Request for Information (RFI) Notice 01
Solicitation # 36C26226B0017
Prescott Replace Steam Boilers
(Project # 649-22-104)

VA Responses in Red

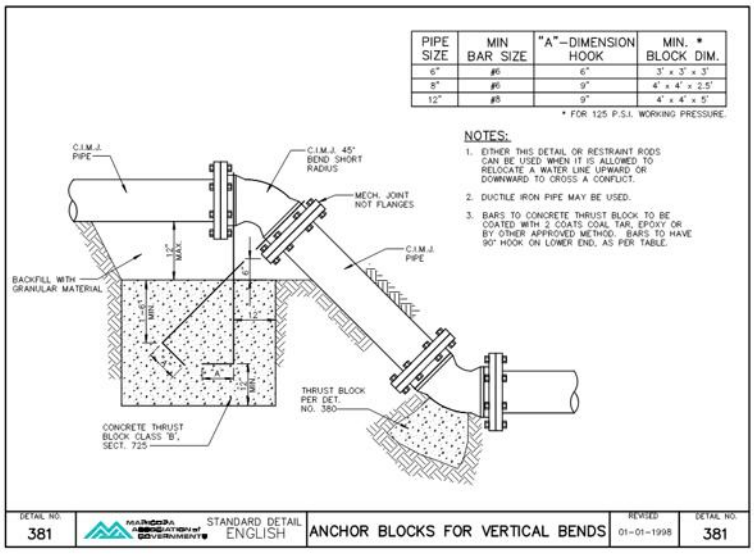
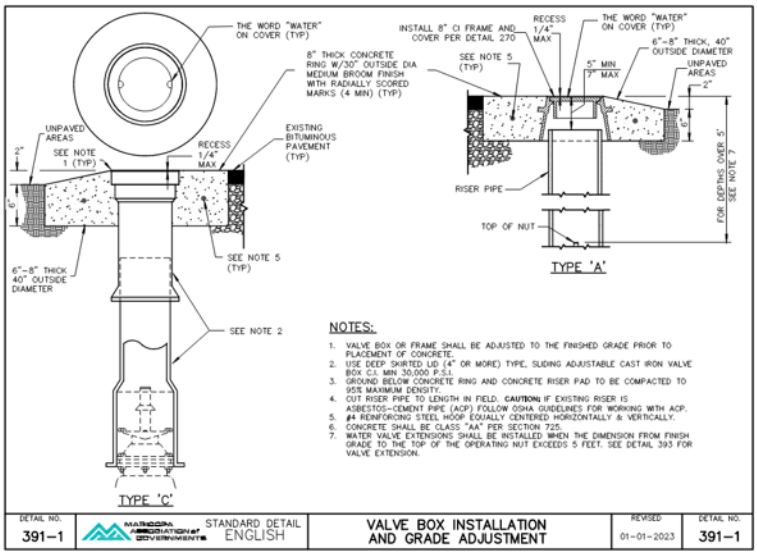
54. Reference CU-1: This sheet references several details along the new fire line piping. eg; Detail 381, 391-1. Can the VA clarify where these details are shown on the drawings?

See details below and attached Maricopa Association of Governments Uniform Standard Details.

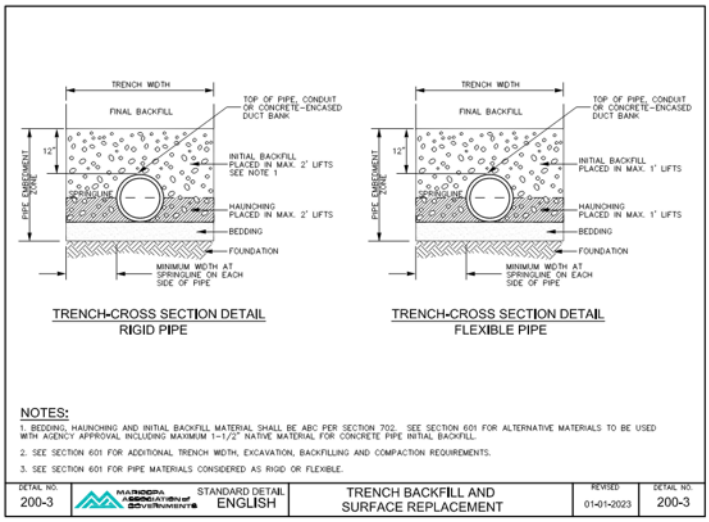
62. Reference CU-1, Note #8: The note states to install water in trench per detail 200-3. Can the VA clarify where this detail is located on the drawings?

See detail below and attached Maricopa Association of Governments Uniform Standard Details.
